**CITY OF HYATTSVILLE**  
**PLANNING COMMITTEE DRAFT MINUTES**  
**MAY 18, 2021**

### 4. Clay Property, CSP-20007

The following is a point by point response to review comments from the SDRC meeting on 04/30/2021.

**CONCEPTUAL LAYOUT**  
**CONCEPTUAL SITE PLAN**  
**CLAY PROPERTY**  
**CSP-2007**

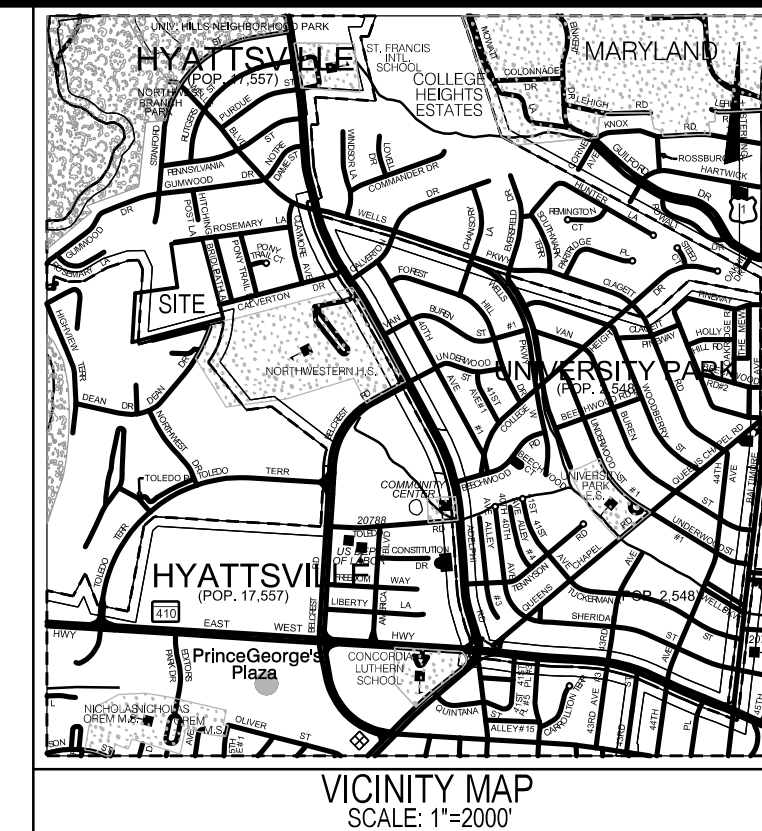
Comment: General note 14 states that a variable width public utility easement is proposed along the internal streets, and that they will be minimum of 4.5' wide. Please revise the note to provide the minimum width of PUE to be 10', in accordance with Section 24-122(a) and Section 24-128(b)(12).

Comment: Though adequacy of on-site recreational facilities will be tested with the PPS, the CSP does not provide for any usable open spaces which could potentially be used to provide such facilities. The applicant is encouraged to identify where adequate recreational facilities would be provided.

Comment: Consider providing a better alignment between the southernmost proposed road and Calverton Drive, in order to provide a simpler intersection between these two roads and Dean Drive.

Comment: Pedestrian connection between Dean Drive and Calverton Drive

Comment: The applicant shall provide emergency vehicle access from Calverton Drive.

**Response: This note has been revised.**

**Response: The plan now shows conceptual locations for open space/rec facilities.**

**Response: This intersection has been reworked to provide a better alignment with Calverton Drive and Dean Drive.**

**Response: A pedestrian connection is proposed between Dean Drive and Calverton Drive.**

**Response: Emergency vehicle access is provided from Calverton Drive.**

**PLAN VIEW SHEET**  
**TREE CONSERVATION PLAN TYPE 1**  
**CLAY PROPERTY**  
 CHILLUM (17th) ELECTION DISTRICT, PRINCE GEORGE'S COUNTY, MARYLAND

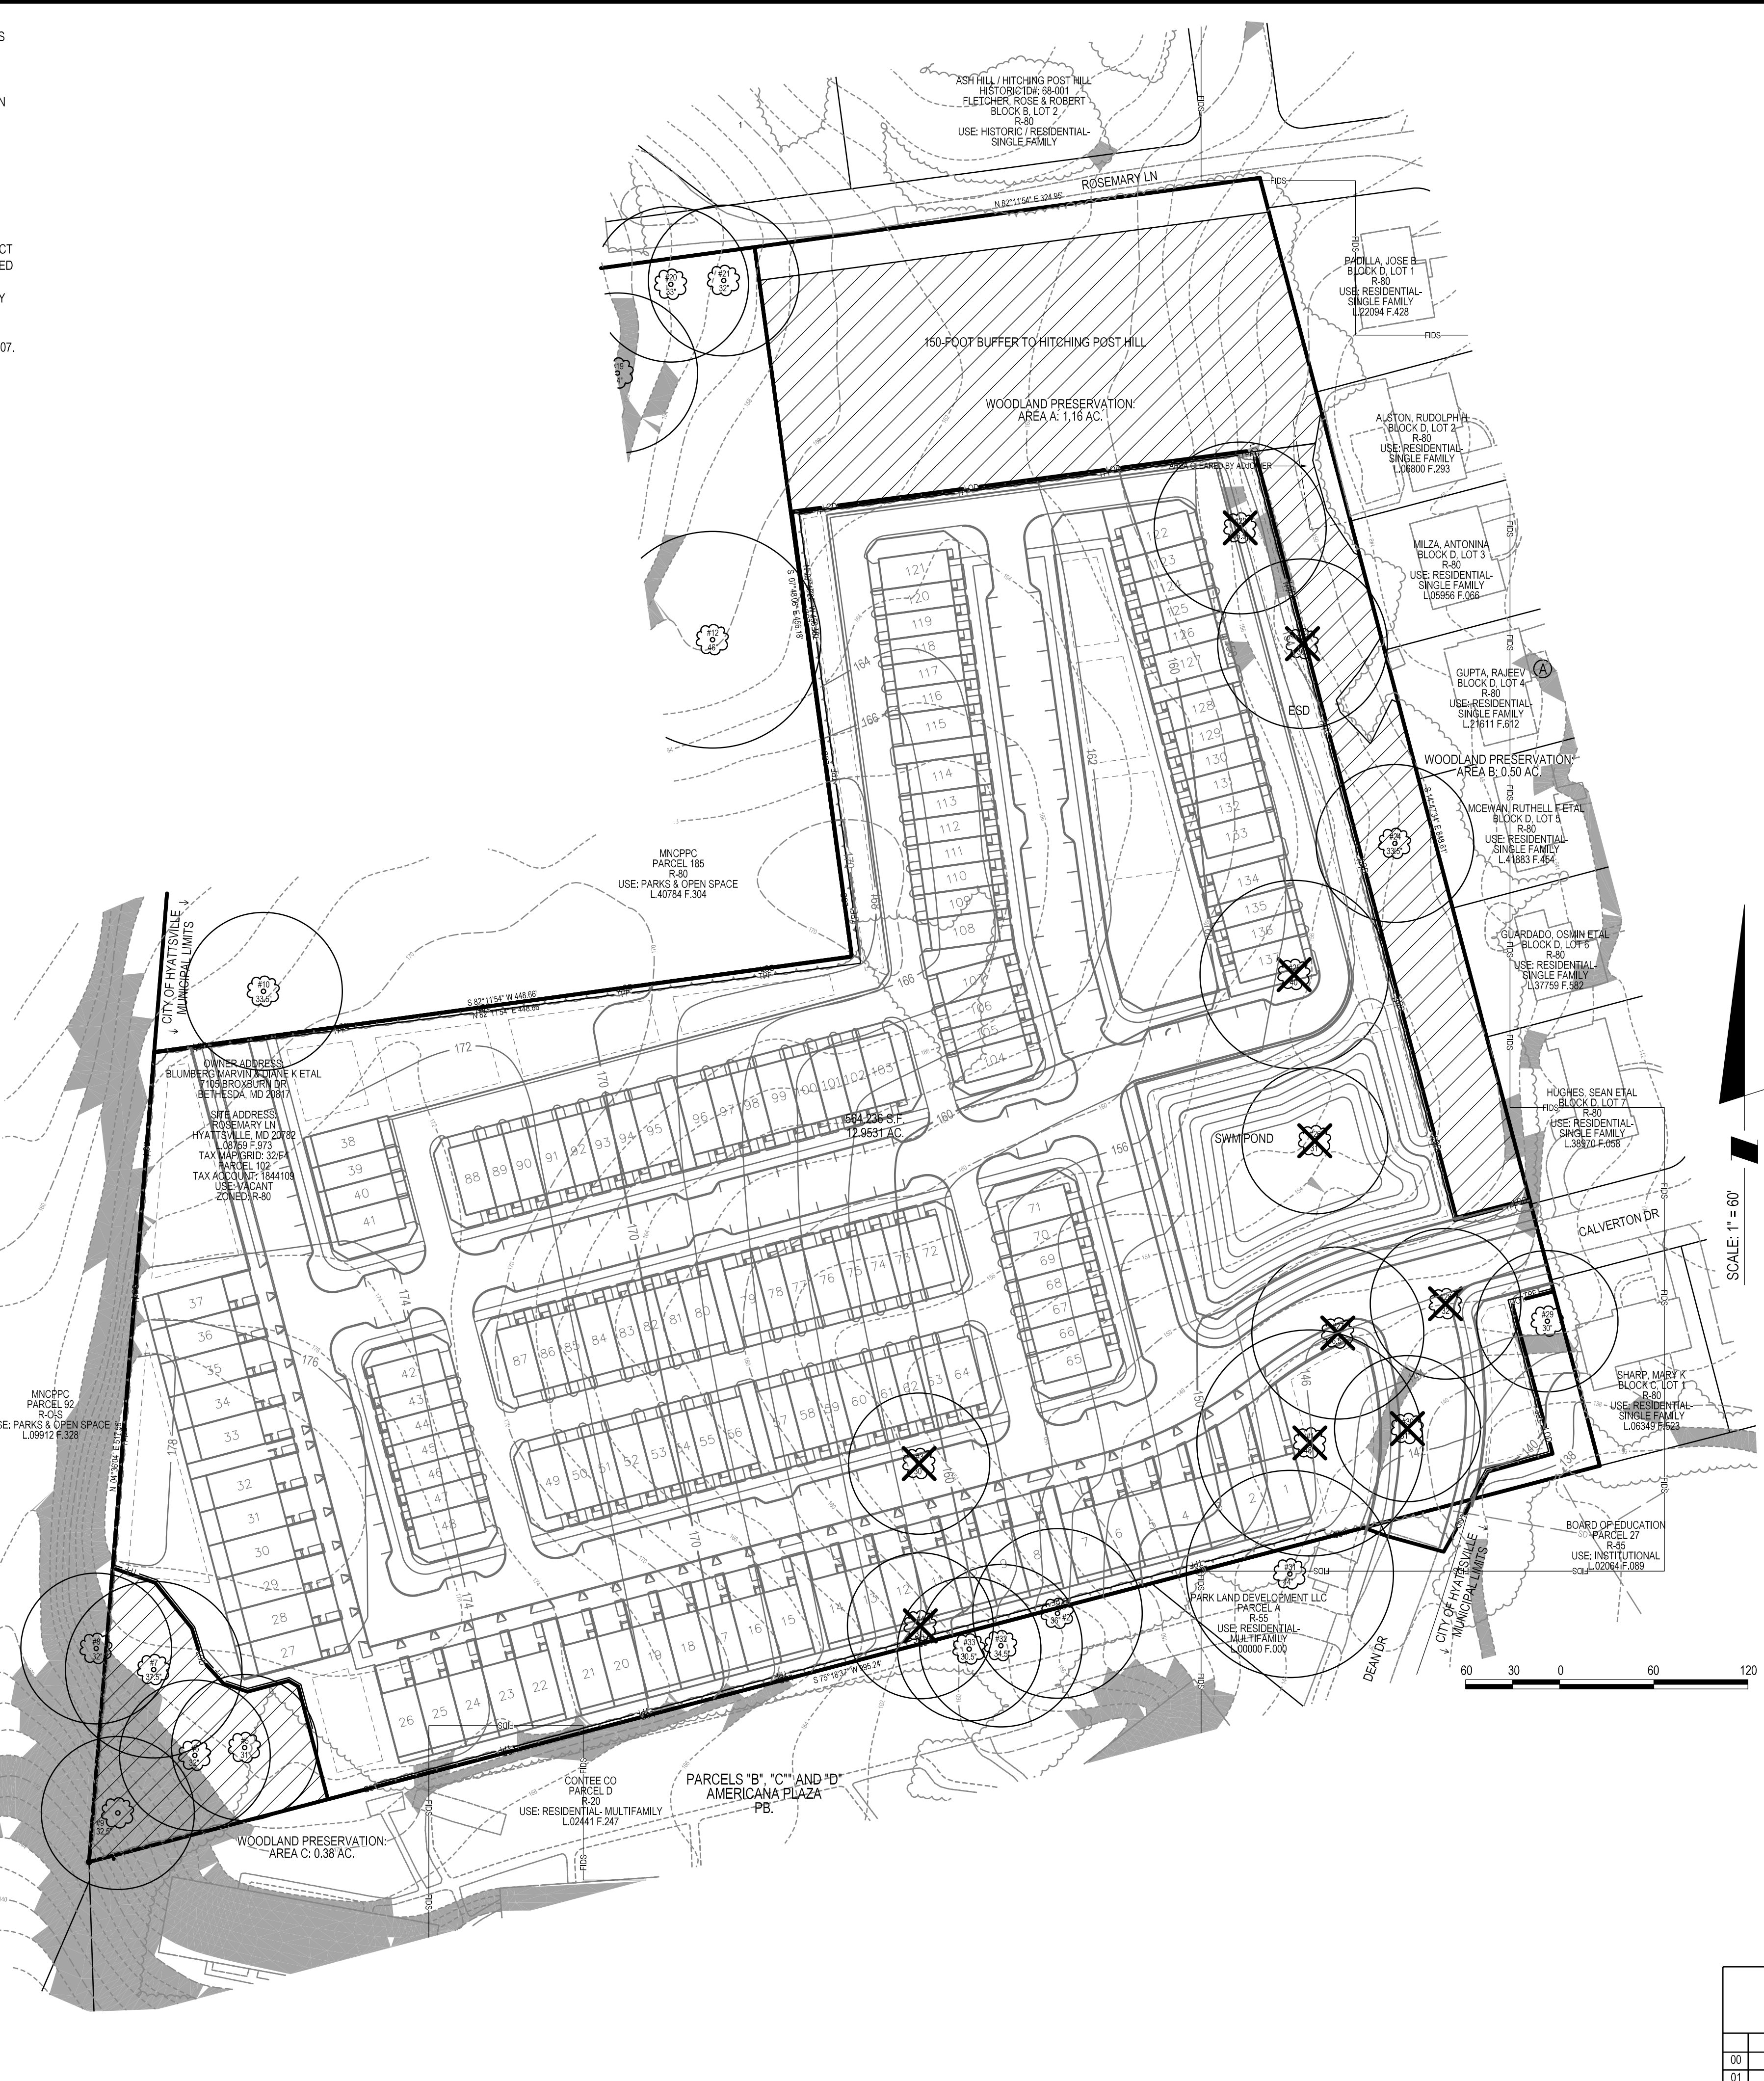
Comment: This site is entirely wooded with a total of 12.61 acres of existing woodlands and 16 specimen trees on-site. The conceptual site plan proposes to remove all the specimen trees and only meet 1.48 acres of the 20% woodland conservation threshold of 2.59 acres on-site. The woodlands proposed for preservation on-site are in lower priority areas of early successional woodlands where other landscape buffering requirements are required to be placed along the site's frontage with Rosemary Lane across the street from a historic site, and with an incompatibility use buffer between the rear yards of existing single-family residential homes to the east and the proposed site (mostly paved) to the west. EPS staff does not find the proposed prioritization of preservation on-site to be adequate per Section 25-121(b) Woodland and Wildlife Habitat Conservation Priorities and Section 25-121(c) Woodland Conservation Requirements. Staff finds that the layout must be redesigned with prioritizing preserving of woodlands to the southwestern portion of the site where more sensitive areas are situated adjacent to steep slopes (some of which are located on unsafe soils containing

**Comment:** Update the TCP1 Worksheet once the above changes to the layout of the plan have been made.

**Comment:** Add a footnote to the specimen trees list stating that the Variance Request for the removal of specimen trees will be reviewed at the time of the Preliminary Plan of Subdivision.

Comment: The acreage of woodland preservation shown on the plan is inconsistent with that of the TCP worksheet. Revise the plan so that all references to woodland preservation are consistent across the plan.

Comment: Update TCP1 General Note #11 to correctly state the stormwater concept plan is pending approval with DPIE.

Comment: Remove all tree protection devices from the legend, since none are required or shown on the TCP1.

Comment: Complete and add the standard Site Statistics Table to the TCP1.

**Response:** **With the redesign of the layout, the CSP now proposes to save 7 specimen trees and meet 2.04 acres (16%) of the 20% woodland conservation threshold of 2.59 acres. This redesign saves more woodland and specimen trees in the southwestern corner of the site. Efforts will be made through the continuing design process to reach the 20% woodland conservation threshold.**

**Response:** **The TCP1 worksheet has been updated.**

**Response:** This footnote has been added.

**Response:** These are now consistent.

**Response:** This note has been updated.

**Response:** These have been left on the legend, as tree protection is now proposed.

**Response:** This has been added.
